MURPHY CREEK EAST SUBDIVISION

AMENDMENT TO THE PUBLIC IMPROVEMENTS PLAN

Report Date:
November 2018
Revised: January 2019
Revised: March 2019
Revised: October 2019
Revised: November 2019

SHEET NUMBER	E1
--------------	-----------

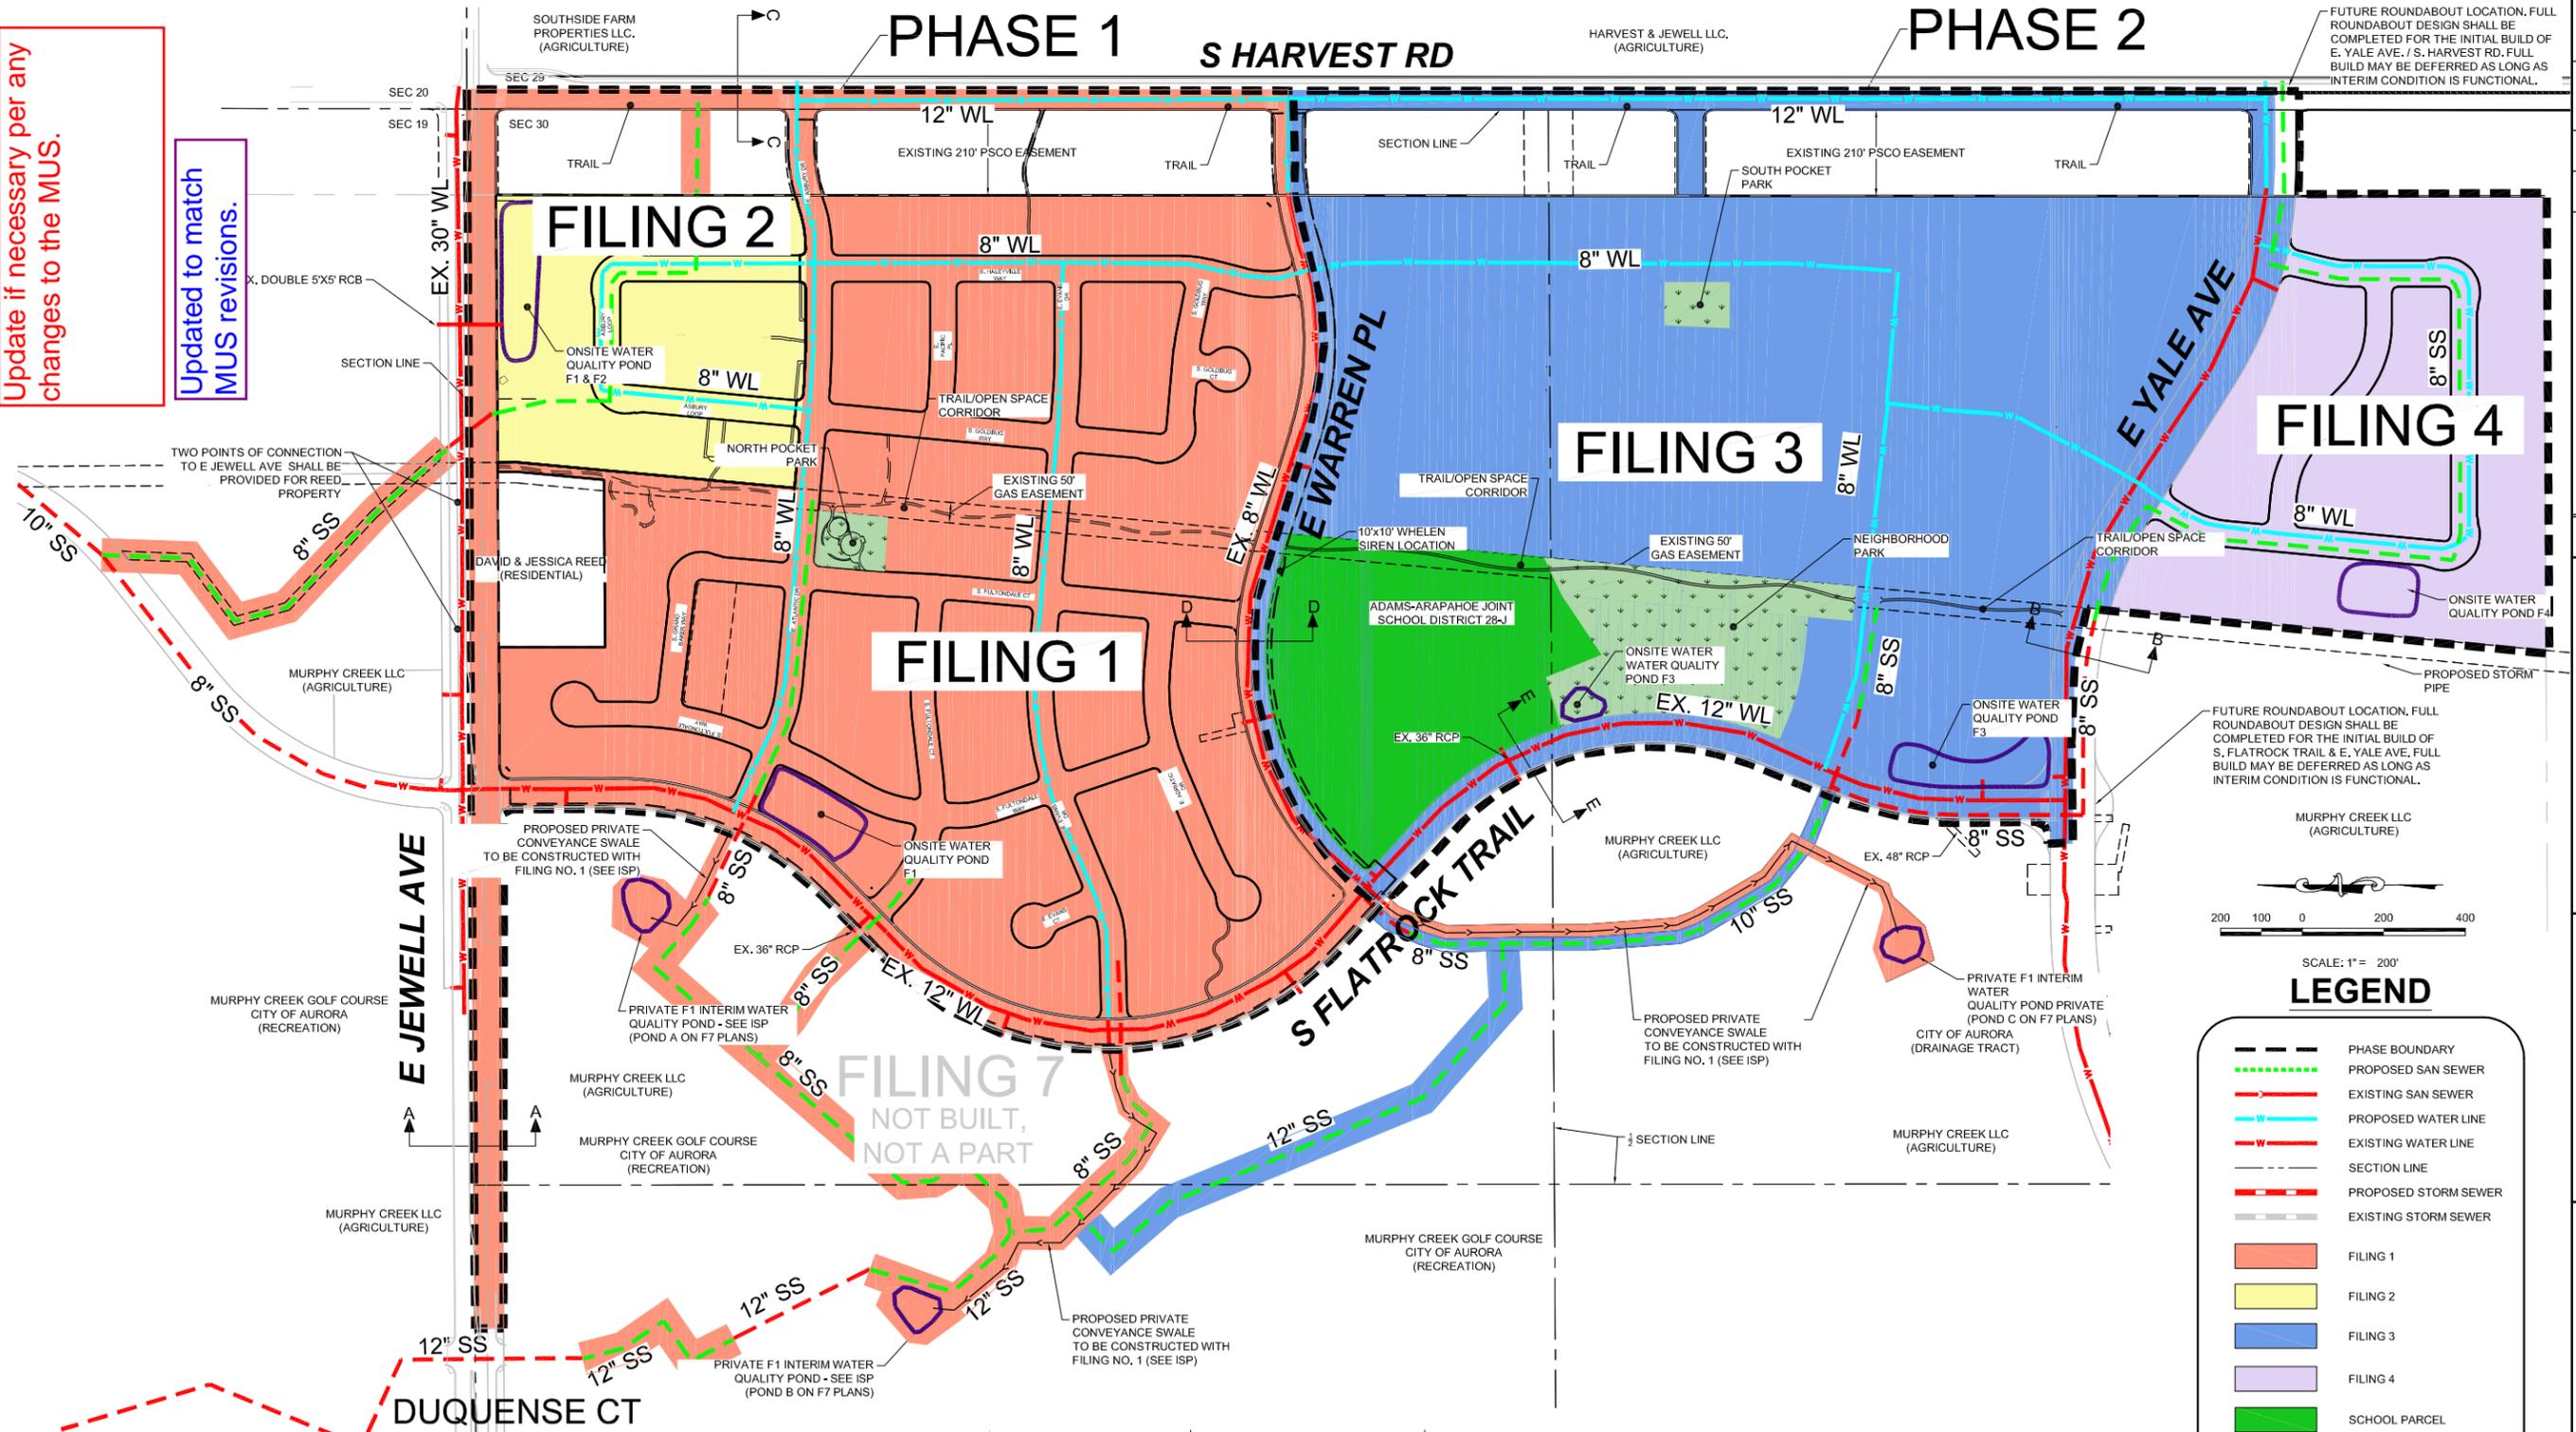
Update if necessary per any changes to the MUS.

Updated to match MUS revisions.
